HEAVY VEHICLE LOCAL ROAD REPORT

Sydney Metro West – Western Tunnelling Package
Clyde/ Rosehill

Document Title	Clyde/ Rosehill Heavy Vehicle Local Road Report
Project Name	Sydney Metro West – Western Tunnelling Package
Client	Sydney Metro
Document Reference No.	SMWSTWTP-GLO-CLJ-HS-RPT-000001-D.01
Revision Date	7 June 2022

REVIEW COMMENTS SHEET

CLY-SPA-03

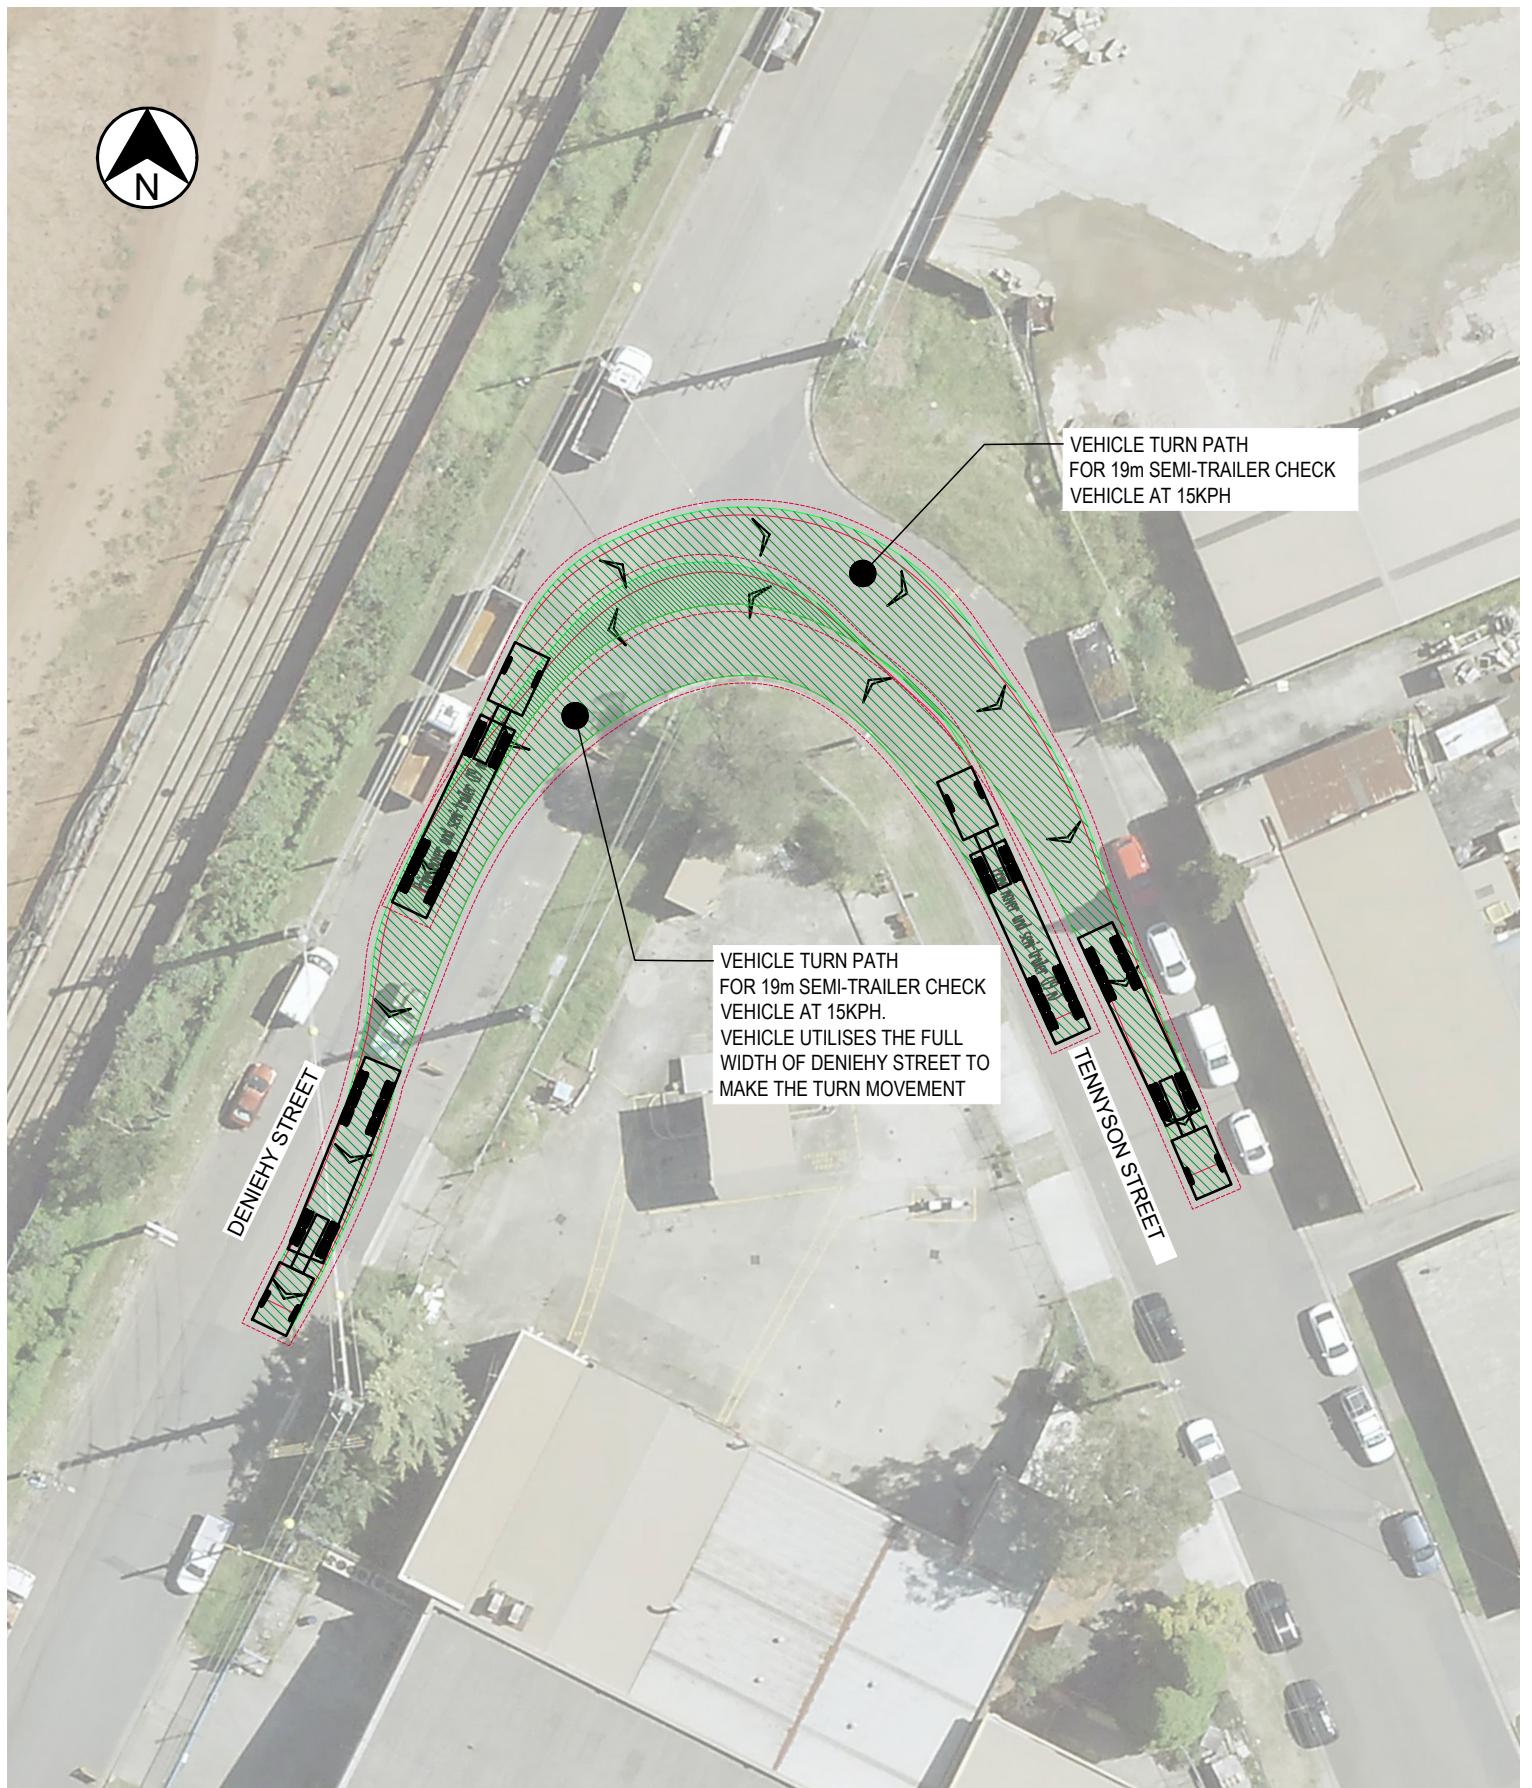
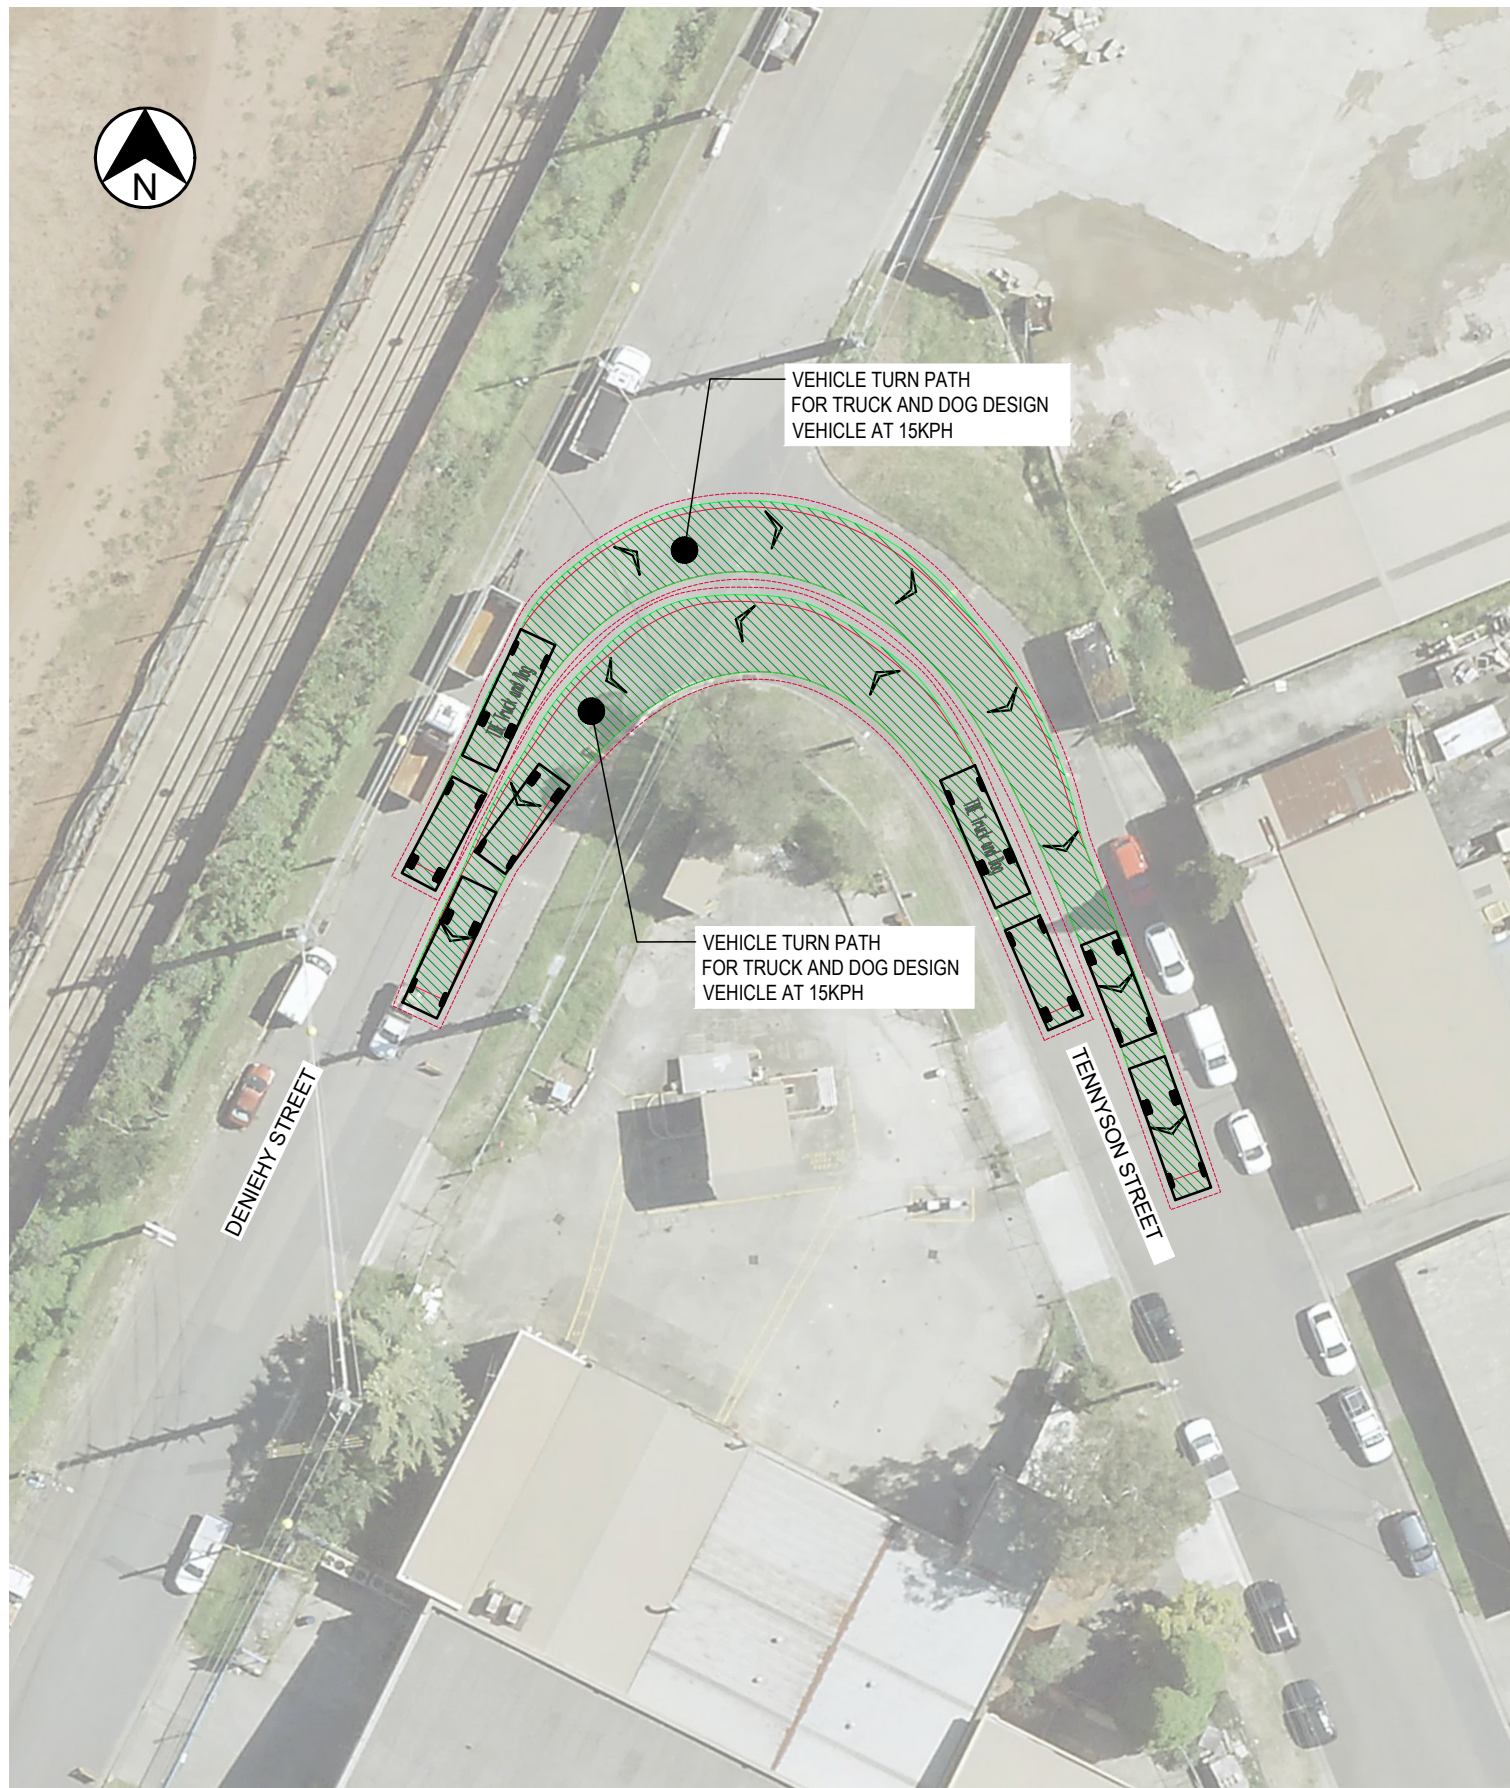
04.01	17/05/2022	GLO	SBESIM	SMWSTWTP-GLO-CLJ-HS-RPT-000001-B.01	Table 6	tba	The swept paths are provided in Appendix A. Concurrent swept paths are shown at all locations. All swept paths are suitable other than as noted in the report	Observation	Y
								SMWSTWTP-GLO-CLJ-HS-RPT-000001-B.01	Table 6	tba		Observation	Y
				05	27/04/2022	TFN	LWILBY	SMWSTWTP-GLO-CLJ-HS-RPT-000001	Appendix A Swept Path Analysis - CLY-SPA-03	NA	The swept path for semi trailer movements between Deniehy St and Tennyson St show significant encroachment into the oncoming traffic lane on a tight bend. Please confirm how these movements will be managed to reduce the risk of collision with other heavy vehicles or road users.	Observation	Y
								SMWSTWTP-GLO-CLJ-HS-RPT-000001	Appendix A Swept Path Analysis - CLY-SPA-03	NA		Observation	Y
